## Technical change to RS SERIES - Relay modules

PCN-number: 20210819

Representative RS relay interface

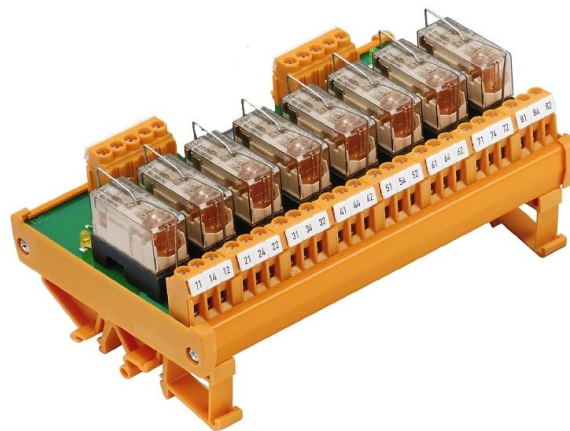
Articles on Section 5 were delivered in the past with LP connectors. Furthermore, they were delivered with Dekafix\*

\*Dekafix is the universal marker for terminals, plug-in connectors and electronic modules from the Weidmüller product range (see detail).

### 2. Technical change

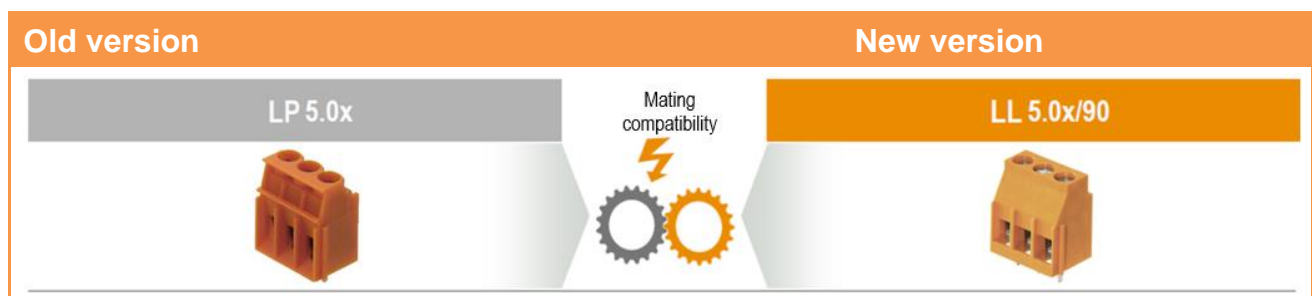
Based on continuous improvement the LP connectors will be replaced by LL Tampoprinted connectors

Obsolescence of LP connector range and addition of **UL-recognized** approvals (**UL**) on the label for these products, making each interface UL recognized.
